Date April 3, 2024 **Report No.** 2024-201
To Chair and Members
City of Brantford Committee of Adjustment
From Lindsay King
Development Planner

Committee of Adjustment Decision Regarding Applications for Consent and Minor Variance

APPLICATION NO.: B15-2024, A15-2024
AGENT: The Angrish Group
APPLICANT/OWNER: Kevin Walchuk (111 Pearl Street), Donna Ferrier (113 Pearl Street)
LOCATION: 111-113 Pearl Street

Figure 1 - Proposed Severance and Addition

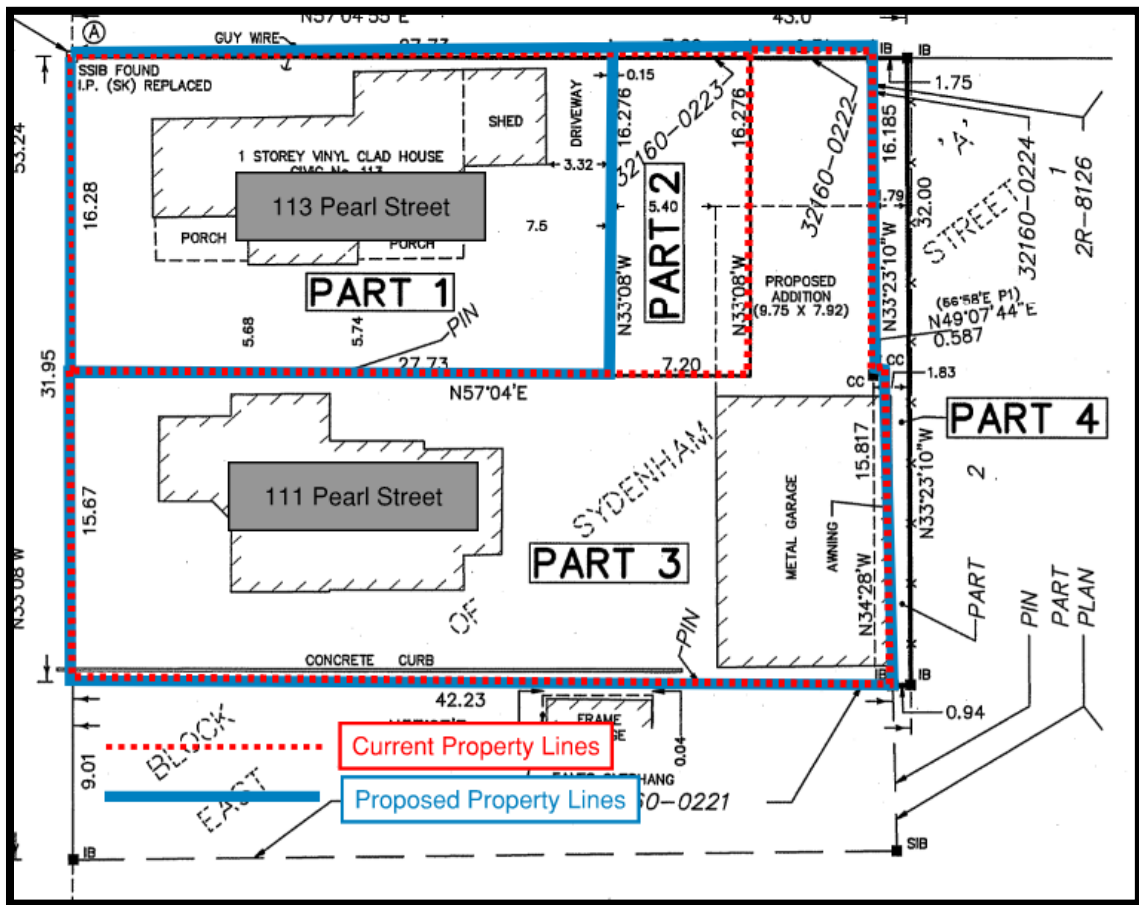
Development Engineering Department staff cannot support a 0 m setback to the adjacent property without an agreement between adjacent property owners addressing stormwater runoff, and ensuring that it would be properly managed and conveyed to the municipal ROW. Staff are furthermore concerned with the maintenance of the hard cap concrete surface on the City owned lands. The 0 m setback does not allow for this conveyance to be achieved as well as prohibits required maintenance and ultimate life cycle replacement of the hard cap surface on the neighboring property.

Building Department staff note that if approved, the addition to the accessory building at the rear of 111 Pearl Street will not be permitted any openings, in accordance with the Ontario Building Code. Building Department staff also note that this building face must have a fire-resistance rating of not less than 45 minutes, using clad and noncombustible materials.

| Four Tests | Discussion |
|--|--|
| 1. That the requested variance is minor in nature | “Minor” is determined by impact, not by the value of the variance being sought. While the proposed 3.32 m rear yard setback for 113 Pearl Street may be considered minor, the proposed 0 m setback to facilitate the addition to the accessory structure on 111 Pearl Street is not considered minor in nature since the absence of a rear yard setback on this site may impede proper stormwater management and maintenance of a remediation site on the rear abutting property. This could pose significant risks to both the subject property and adjacent parcels. The proposed elimination of a rear yard and accessory lot |

| Four Tests | Discussion |
|---|--|
| 2. That the intent and purpose of the Zoning By-law 160-90 is maintained | The proposed variance does not maintain the general intent and purpose of the Zoning By-law. Setbacks serve to ensure harmonious development patterns, maintain privacy, and mitigate adverse impacts such as visual clutter. Granting a variance to eliminate the rear yard undermines these objectives and could compromise the quality of life for neighbourhood residents and future residents. |
| 4. That the variance is desirable for the appropriate development and use of the land, building or structure | Considering the factors listed above, it is evident that the proposed minor variance for the 0 m setback on 111 Pearl Street is not desirable for the site. Granting such a variance could exacerbate existing drainage concerns onto neighbouring properties, potentially compromising environmental integrity and community well-being. The variance request for a 3.32 m setback on 113 Pearl Street only serves to facilitate the extension of the accessory structure, and so this variance is also considered undesirable for the appropriate use of the subject lands. |

- A. THAT application A15-2024 seeking relief from Sections 6.3.1.1 and 6.3.1.3.3 of Zoning By-law 160-90 to permit an accessory lot coverage of 20.1%, whereas a maximum of 18.7% is otherwise permitted, and to permit the extension of a 0 m rear yard setback, whereas 7.5 m is otherwise required, on the lands municipally known as 111 Pearl Street, BE REFUSED;

- C. THAT application A15-2024 seeking relief from Section 7.8.2.1.6 of Zoning By-law 160-90 to permit a rear yard setback of 3.32 m whereas 7.5 m is otherwise required, on the lands municipally known as 113 Pearl Street, BE REFUSED;

- E. THAT Consent application B15-2024 requesting to transfer a parcel of land that is approximately 117.18 m² from the subject property at 113 Pearl Street to the subject property at 111 Pearl Street, BE REFUSED;
